Access Compliance Report Public Rights-of-Way (Curb Ramps)

Intersection ID: 10033470Main Street: OLD_PINEVILLE_RDCross Street: N/ALocation:SWADA ID: 7B7B6192CE08Ramp Type: PerpInitial Pass/Fail: FailOverall Compliance: NoSeverity Score: 12.5

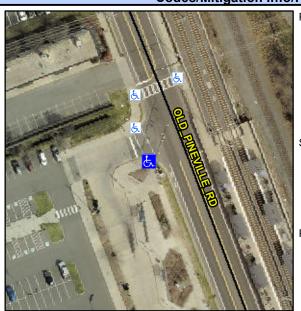
Possible Solutions:	Co
Remove & Replace Entire Ramp.	N/A
	Yes
	N/A
	N/A
	N/A
	N/A
Surveyor Notes:	N/A
N/A	N/A
	N/A
	N/A
	N/A
PROW/ADA:	N/A
Not Found, R304.2.2	N/A
	N/A
	N/A
	N/A

Compliance Description		Data	Compliance Description		Data
N/A	Ramp Length (in)	113.0	No	Ramp Slope (%)	11.1
Yes	Ramp Width (in)	48.0	Yes	Ramp XSlope (%)	0.8
N/A	Flare Type LT	N/A	N/A	Flare Type RT	N/A
N/A	Flare Slope LT (%)	N/A	N/A	Flare Slope RT (%)	N/A
N/A	Flare Traversable LT?	N/A	N/A	Flare Traversable RT?	N/A
N/A	Landing Length (in)	N/A	N/A	DWS Provided?	N/A
N/A	Landing Width (in)	N/A	N/A	DWS Contrast?	N/A
N/A	Landing Slope (%)	N/A	N/A	DWS Length (in)	N/A
N/A	Landing X Slope (%)	N/A	N/A	DWS Full Width?	N/A
N/A	Landing Curb? (Y/N)	N/A	N/A	DWS Offset (in)	N/A
N/A	Shared Landing?	N/A			
N/A	Gutter Ponding?	N/A	N/A	Gutter Slope (%)	N/A
N/A	Gutter Lip Ht (in)	N/A	N/A	Gutter X Slope (%)	N/A
N/A	Painted X Walk1?	Yes	N/A	Painted X Walk2?	N/A
	X Walk 1 Direction	To NW		X Walk 2 Direction	N/A
N/A	X Walk 1 Width (in)	100.0	N/A	X Walk 2 Width (in)	N/A
	X Walk 1 Slope (%)	1.2		X Walk 2 Slope (%)	N/A
	X Walk 1 X Slope (%)	4.3		X Walk 2 X Slope (%)	N/A
